Technical Service Information Bulletin

FRONT SUSPENSION SUPPORT NOISE

'97-'00 ES 300 & '99-'00 RX 300

SUSPENSION
SU002-99

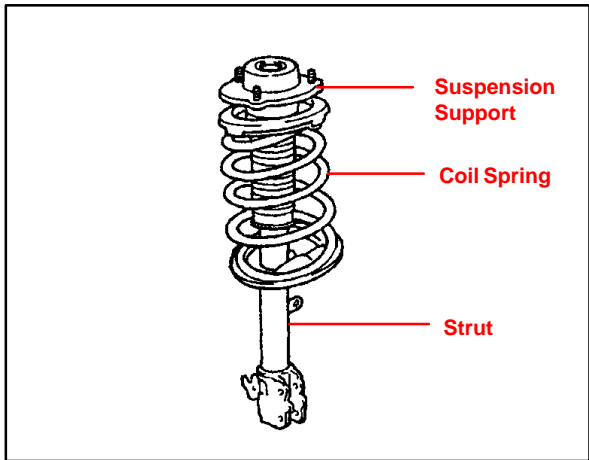
Introduction To eliminate a noise occurrence from the front suspension on washboard type road surfaces, the suspension support has been changed.

Production Change Information The rubber bushing shape of the suspension support has been changed.

PREVIOUS PART NUMBER	CURRENT PART NUMBER	PART NAME	QTY
48603-33020	48603-33021	Support Sub-Assembly, Front Suspension RH	1
48609-33120	48609-33121	Support Sub-Assembly, Front Suspension LH	1
